Addendum 2

Project Stadium New Press Box – Marlin ISD
Issued December 8, 2023 by CEI Engineering Associates, Inc.
Proposal Opening December 14th at 2:00 PM

ADDENDUM NO. 2

PROJECT: Marlin ISD - Pressbox
HKS Project No. 26095.000

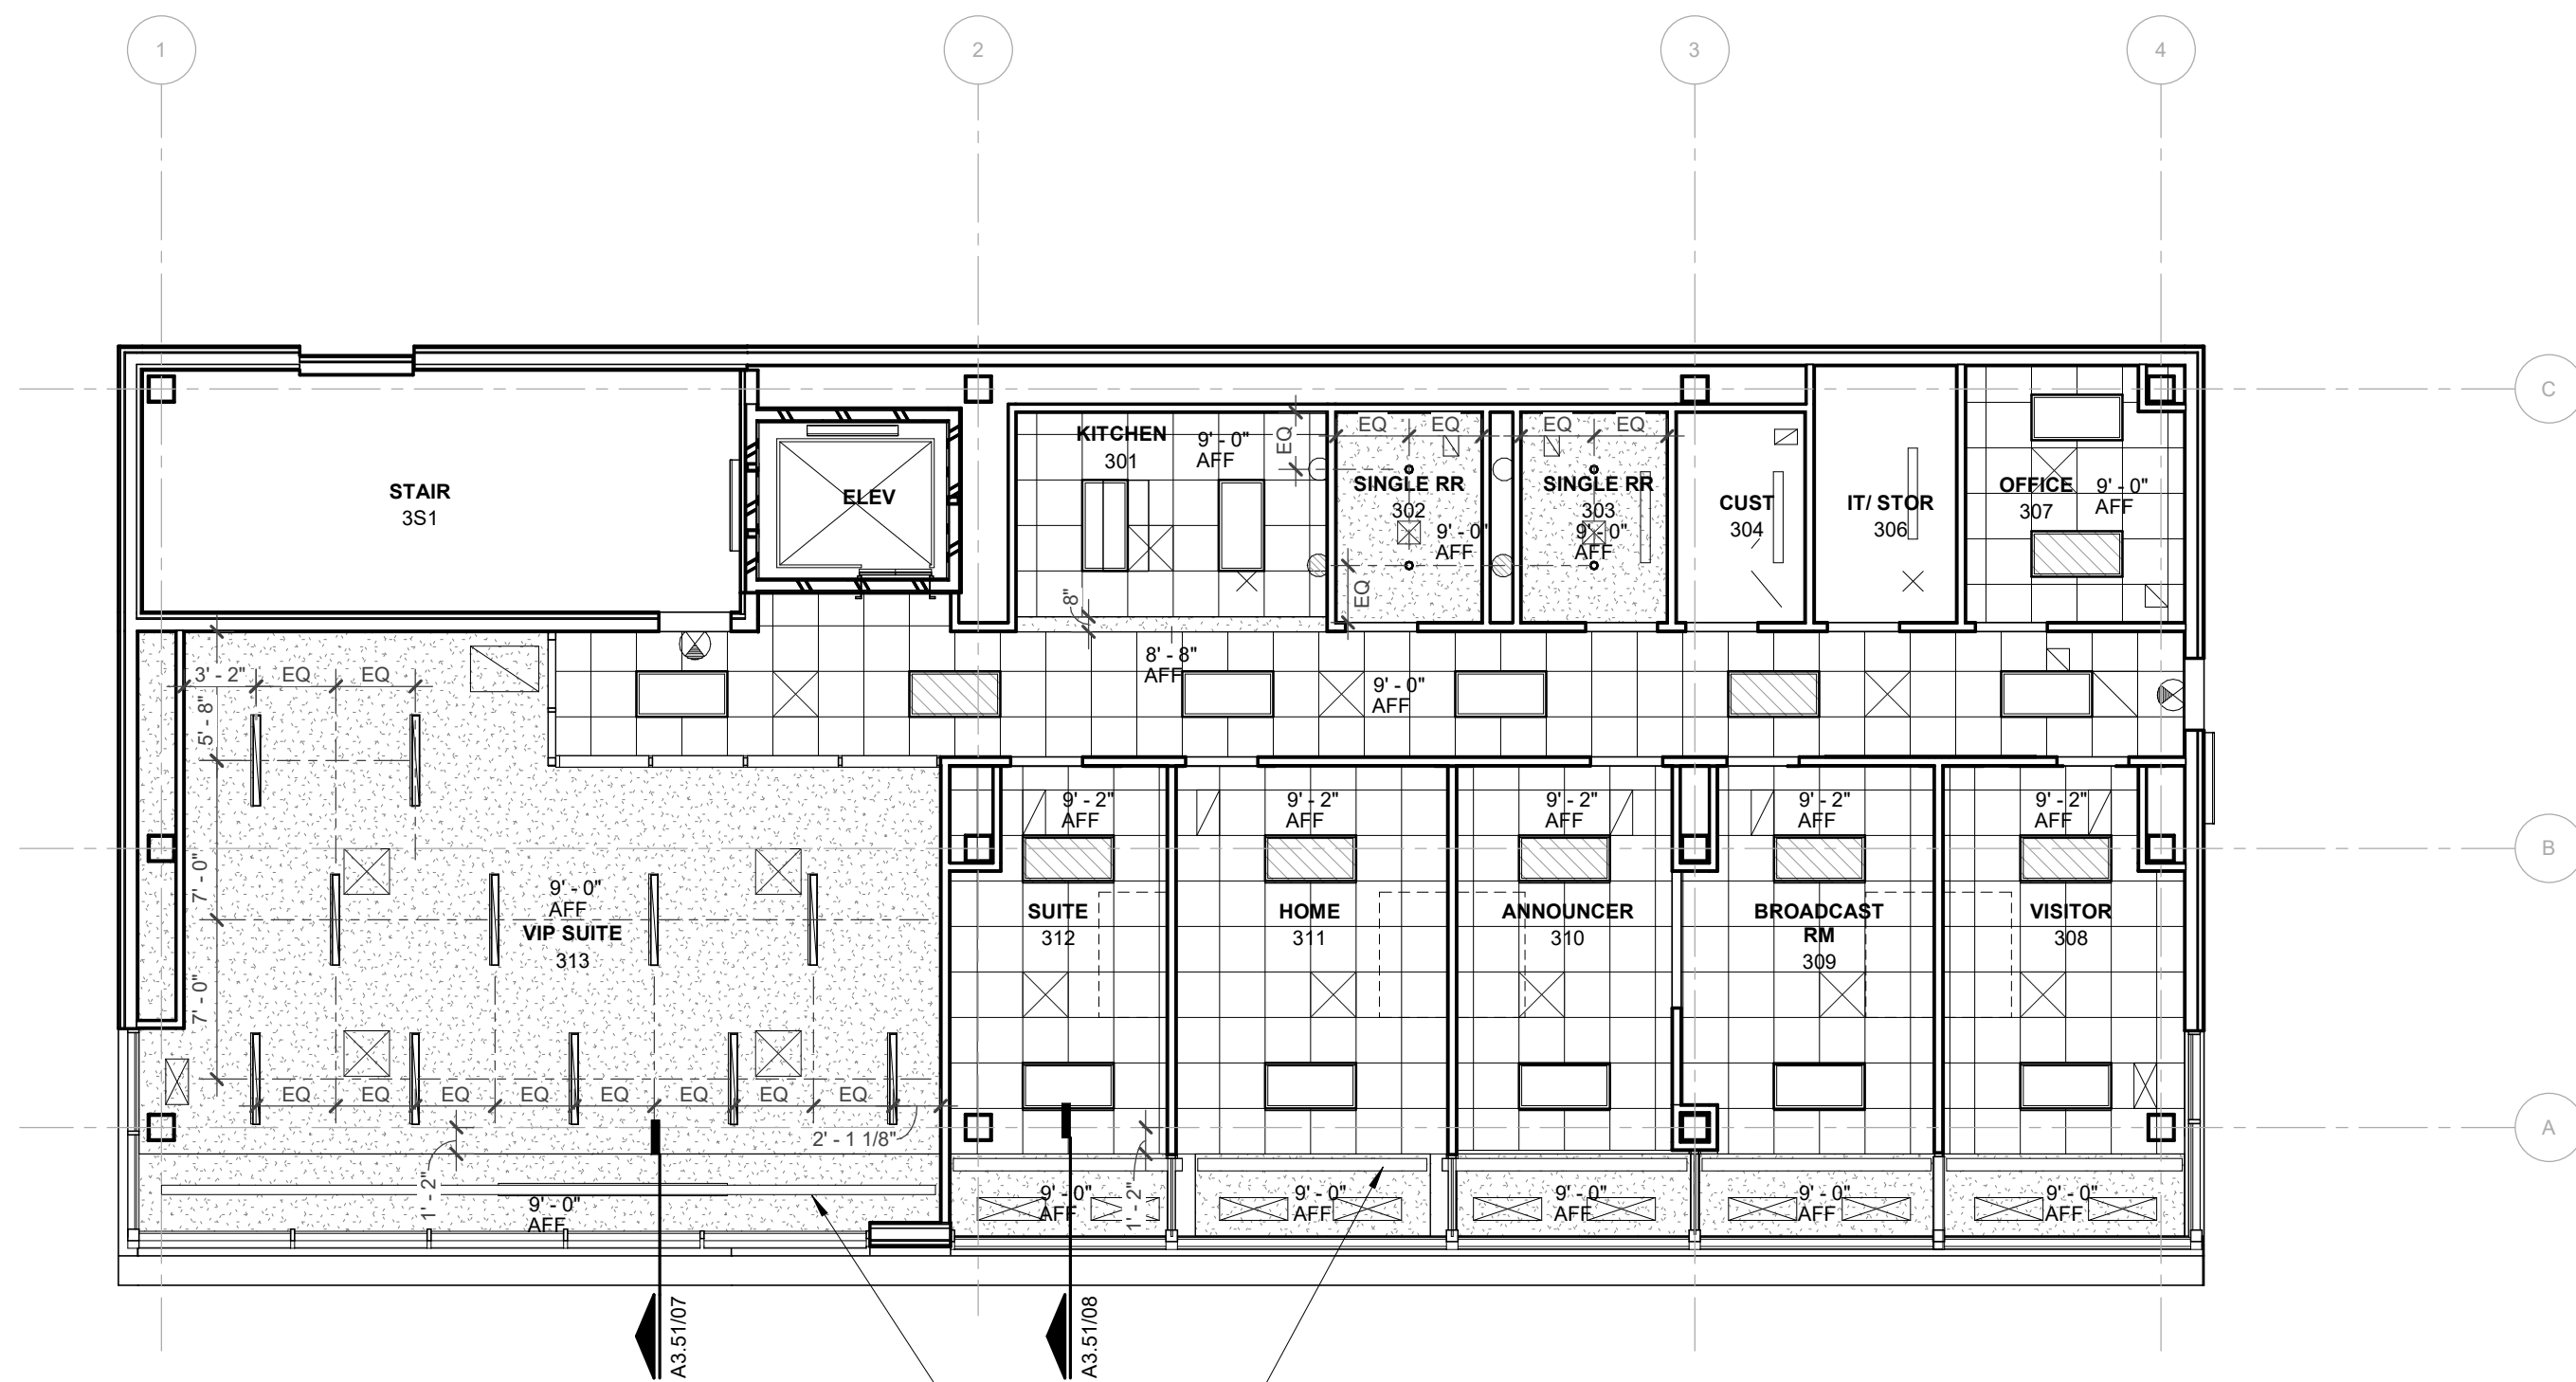
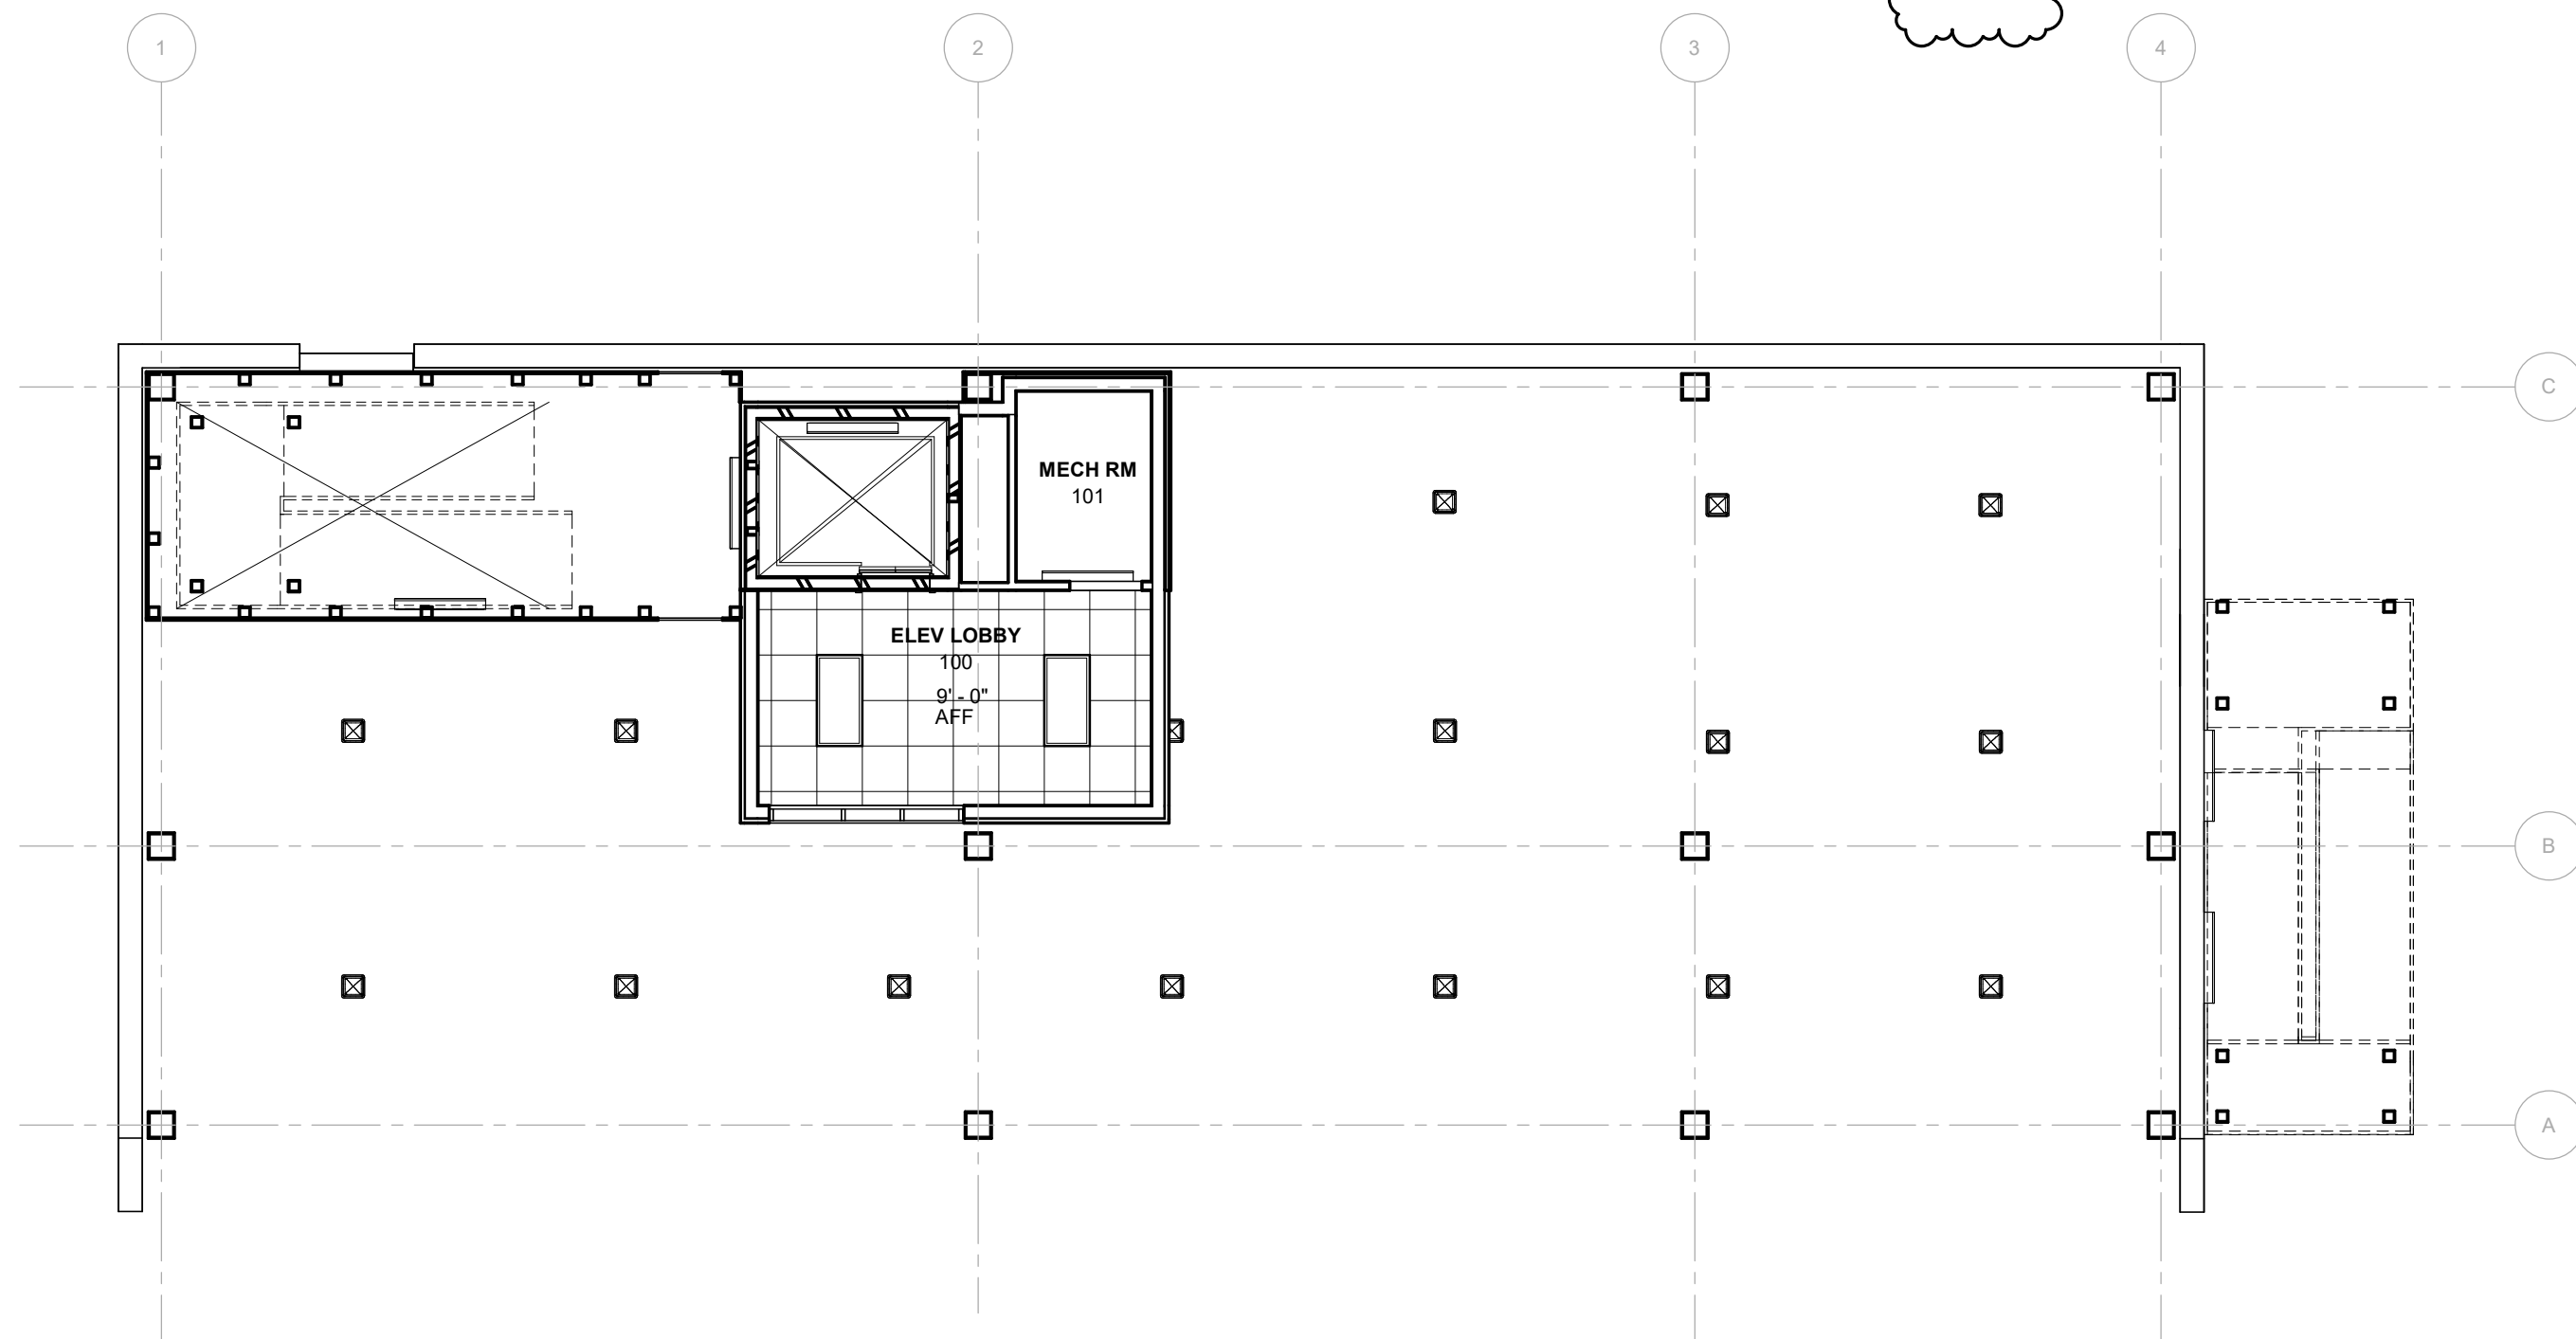
- Adjusted Detail 05
- **A4.00 – REFLECTED CEILING PLAN**
 - Added RCP for the ground level
 - Added ceiling and lights for elevator lobby
 - Adjusted ceilings and lights at Pressbox Level to match floor plan changes
